Willow Cove Phase 2 Concept Planning Commission Report		
Applicant:	Ivory Development	
Requested Action/Purpose:	Review and recommendation on a concept	
Location:	Approx. 900 West 300 South	
Project Area:	7.03 acres	
Existing Zoning:	A-1	
Existing General Plan Land Use Designation	Low Density Residential	
Adjacent Zoning and Land Use:	<i>North:</i>	A-1 Undeveloped
	<i>South:</i>	R-1-8 Single-family residential (Creekside Farm)
	<i>East:</i>	A-1 Undeveloped
	<i>West:</i>	RA-1, R-1-8, County Single-family residential (Saddlebrook)
Date of Last DRC Review:	February 3, 2016

**Willow Cove Phase 2 Concept Review
DRC Comments**

Ivory Development – Requests Concept Plan review for Willow Cove Phase 2, a 20-lot residential development located at 900 West 300 South in a proposed R-1-Flex zone.

WILLOW COVE, PHASE 2 / HESS COMPOSITE

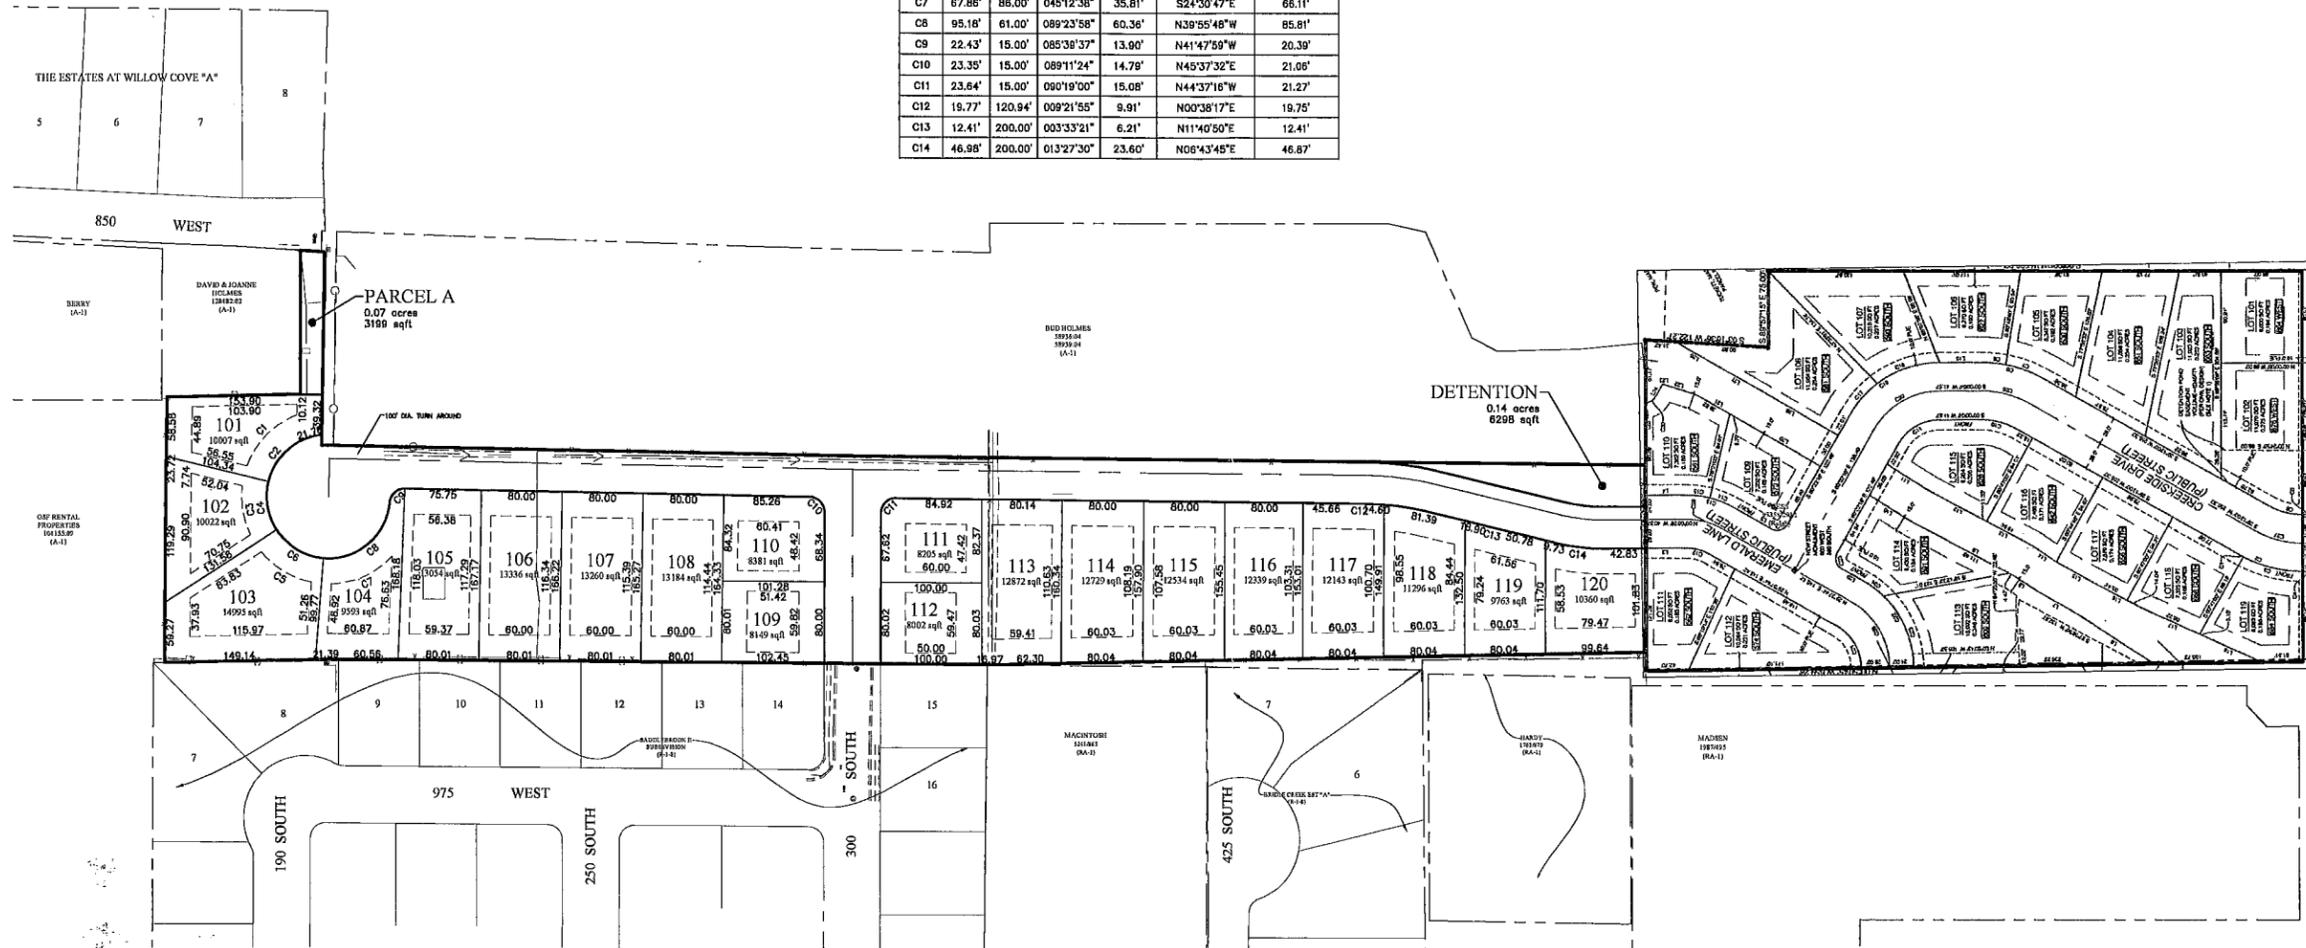
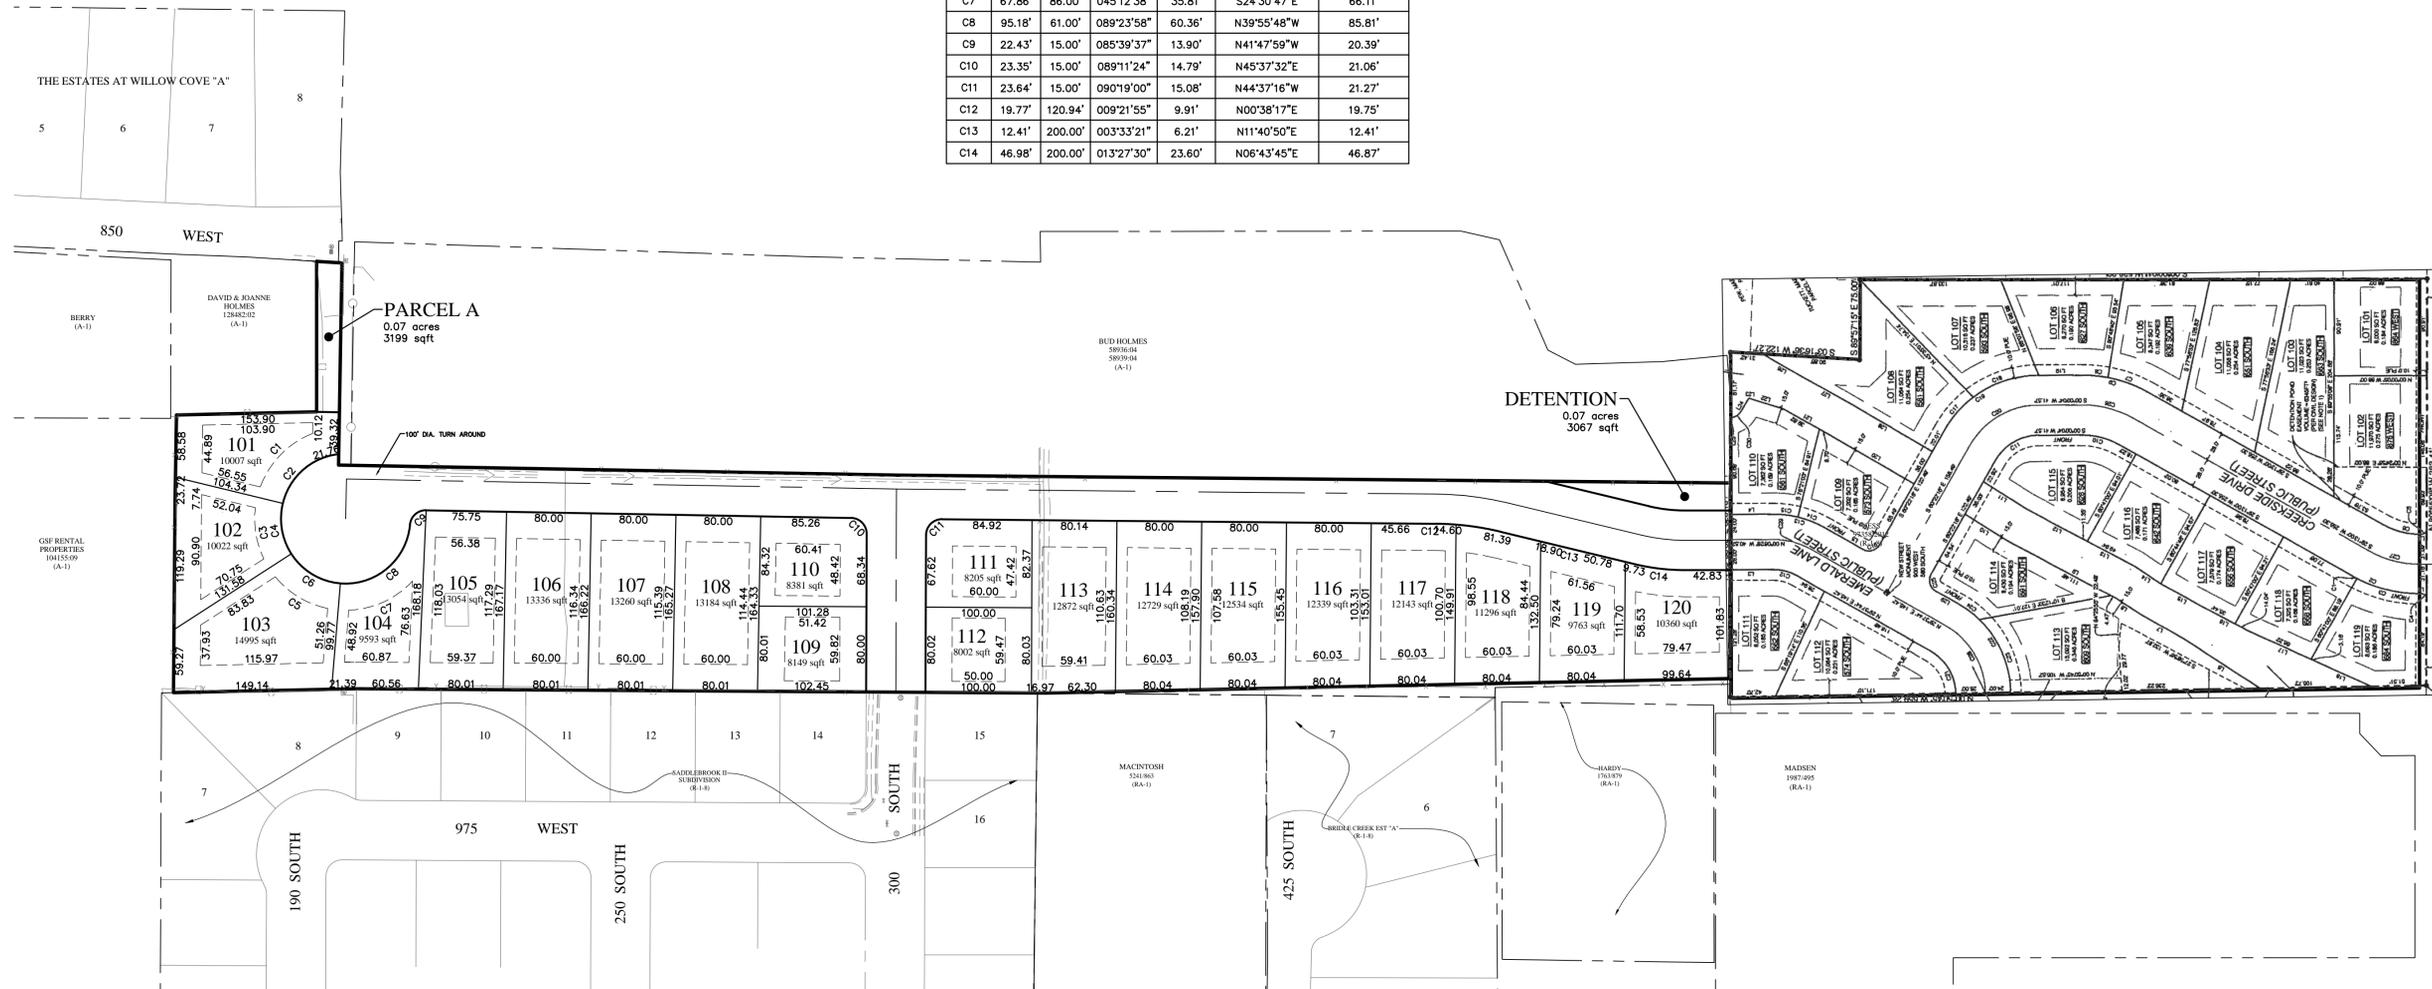
There is an existing building on the lot that will need to be identified and labeled as to whether it will remain or be removed at the time of subdivision. There also seems to be a shed on the property to the west at 957 West 300 South which has a shed/accessory building that crosses over the property lines and will need to be addressed.

Since several neighboring properties are in agricultural zones, a right-to-farm analysis will be required at the time of subdivision application. The DRC commented that there is a Lehi irrigation ditch that crosses the property and needs to be addressed with development. Please consider other DRC comments as part of the motion.

- a) At the time of final review, show the existing nearby electrical equipment.
- b) Please provide a ‘dwg’ format drawing to the Power Department for the circuit design and conduit/equipment placement. Send to: gladek@gwmail.gwu.edu

- c) There is a Lehi Irrigation ditch that crosses the property that will need to be addressed as the project moves forward.

- d) Need to show the full road section along the detention basin at the south end of the project.

- e) Provide a soils report at the time of Preliminary Subdivision application.

- f) The road section the developer will need to build is a 41’ section.
- g) If the detention ties into Dry Creek, a Stream Alteration Permit will be required.
- h) This development needs to connect to the utilities in 300 North and Emerald Lane.
- i) If the grade of the road is much higher than the adjacent property and will require a wall or a slope easement with an agricultural right-to-farm fence.

- j) Revise detention. Recommend incorporating detention into a lot.
